PCO / DETENTION / DRAINAGE PLAN

PRELIMINARY PLANNED MULTI-FAMILY SUBDIVISION APPROVAL

*Revision to approved plans to accommodate building
change due to fire code requirements (additional clearance
from adjacent parcel, plus addition of a no-build easement to
further satisfy building standards).

SHARON TOWERS VILLA APARTMENTS PHASE 2 - VILLA 'B' CHARLOTTE, NC

COVER

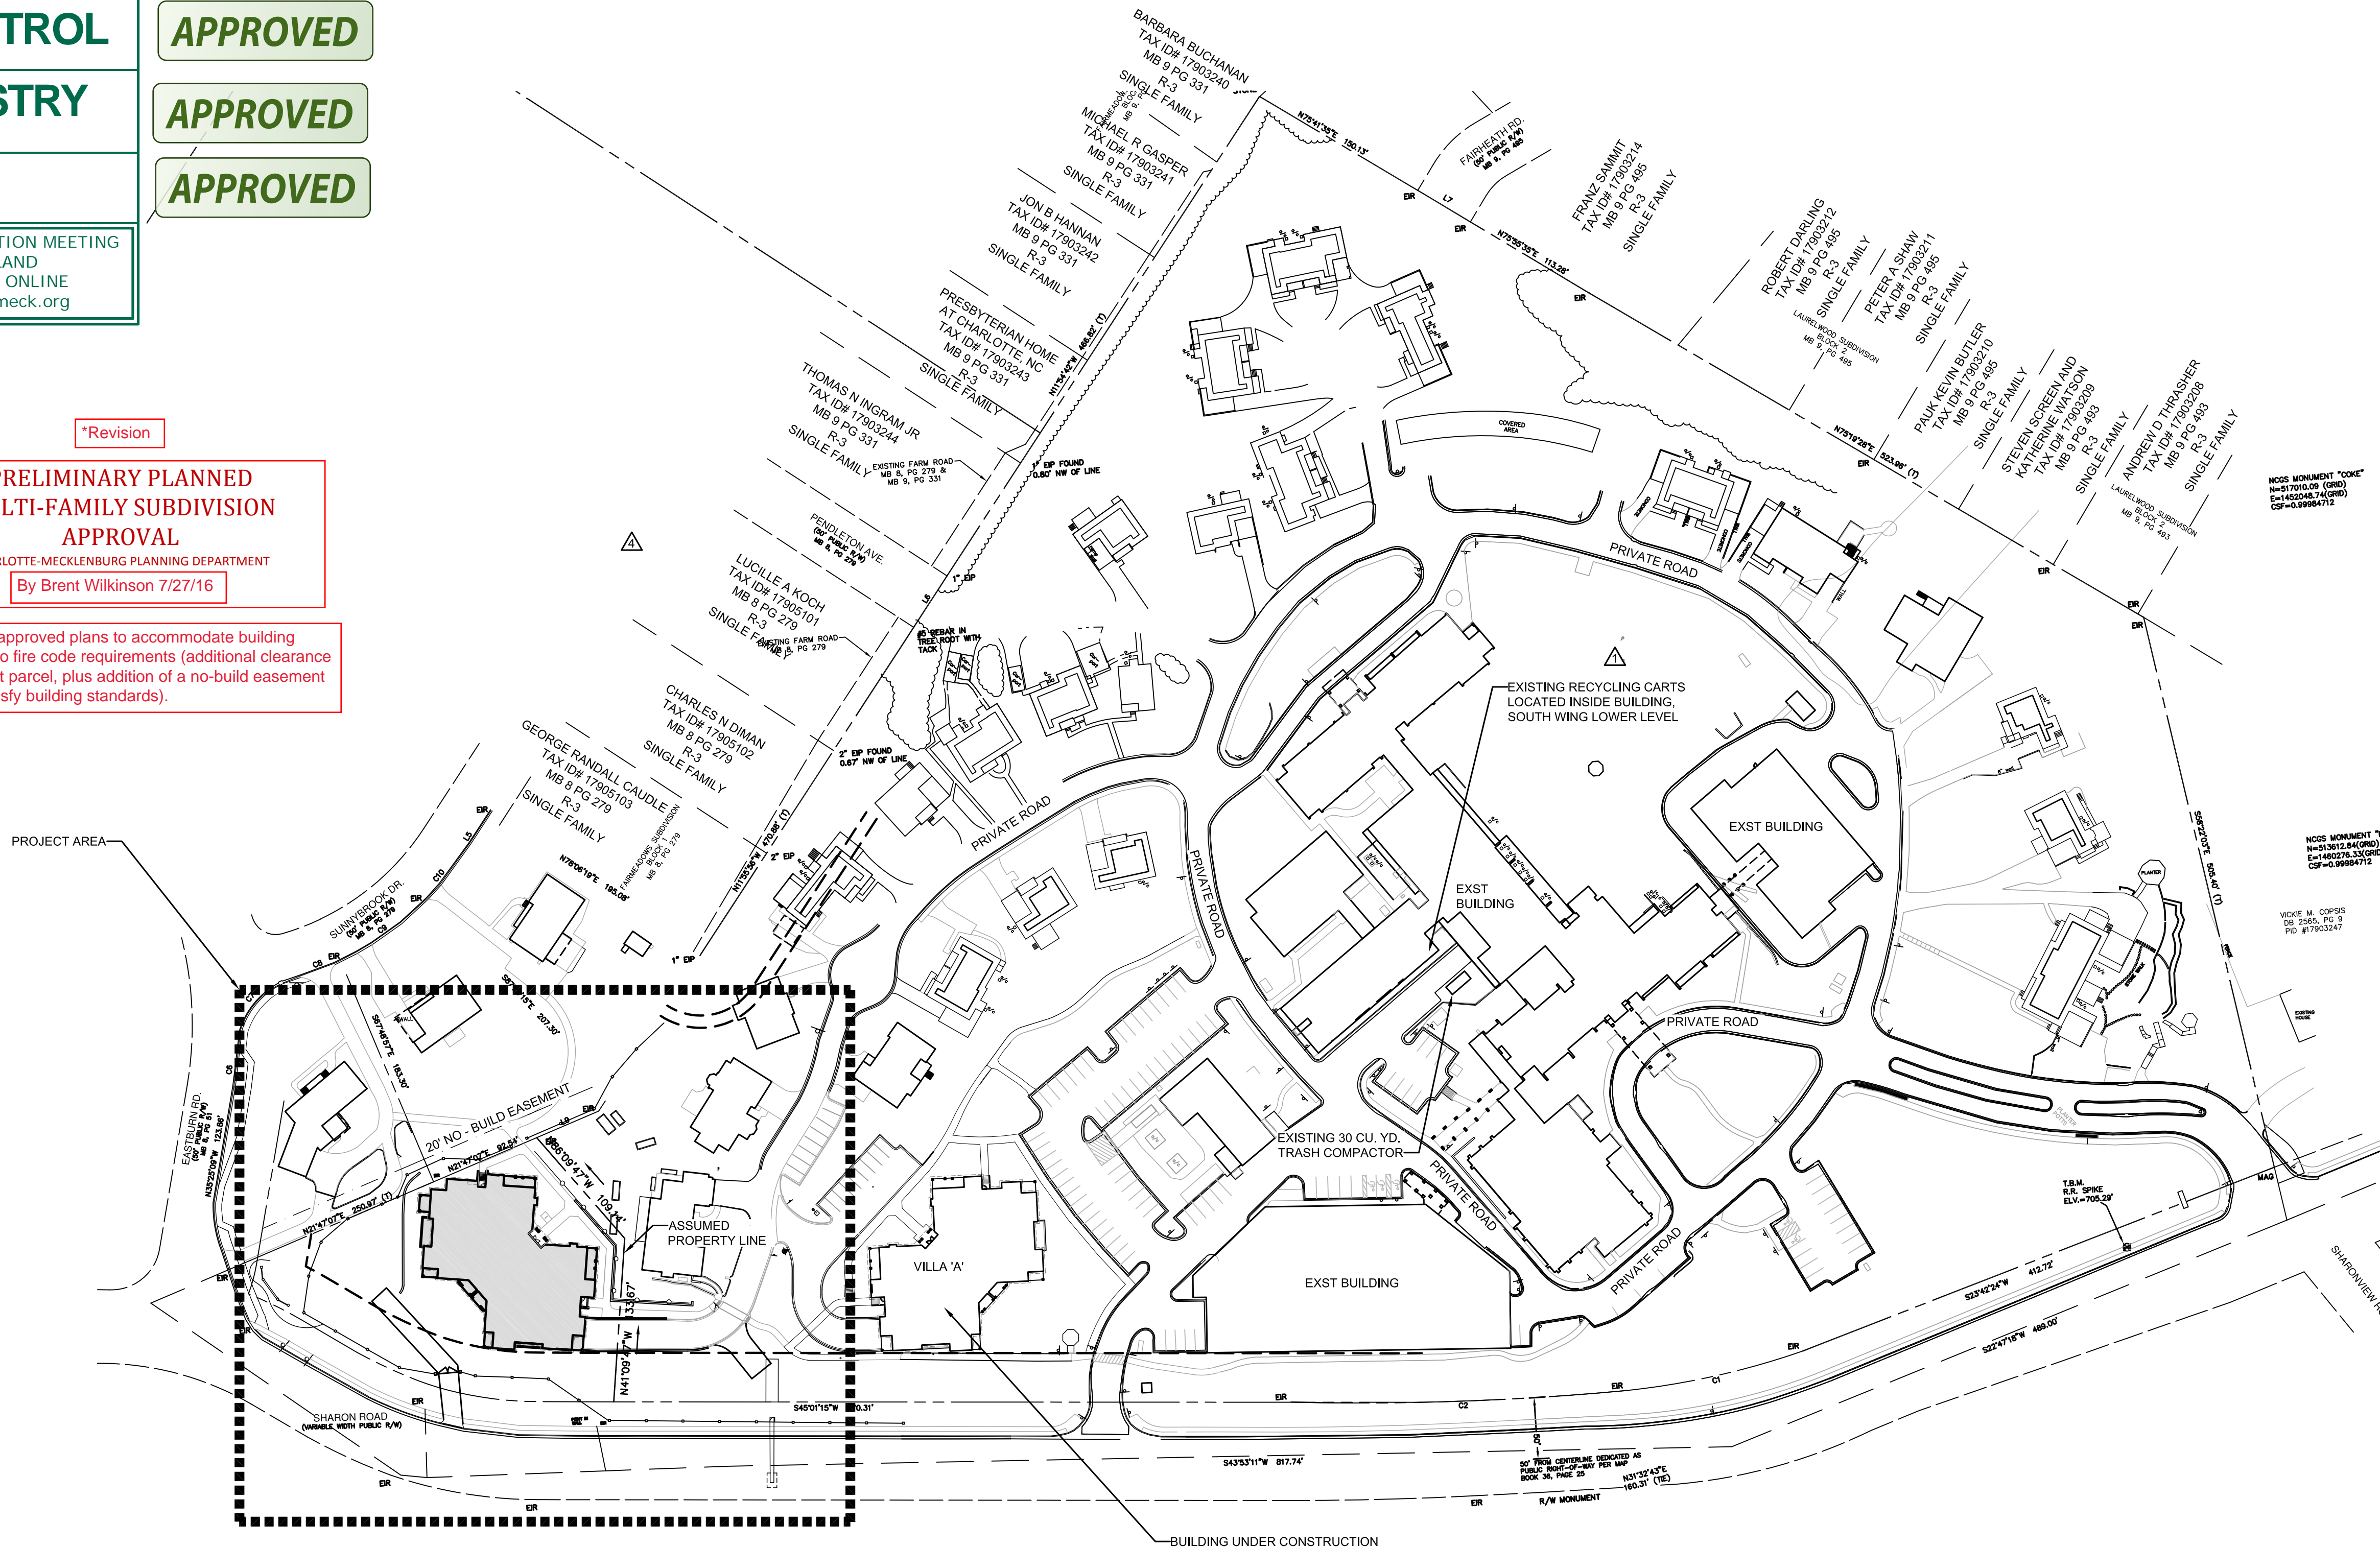
REVISION #1 (1-22-16) INCLUDES REVISIONS
BASED ON FIRST REVIEW COMMENTS, AS WELL
AS CHANGES ASSOCIATED WITH RAISING THE
FFE OF VILLA B, INCLUDING (BUT NOT LIMITED
TO) MODIFICATIONS TO THE GRADING, STORM
DRAINAGE SYSTEM, RETAINING WALL
LOCATIONS AND HEIGHTS.
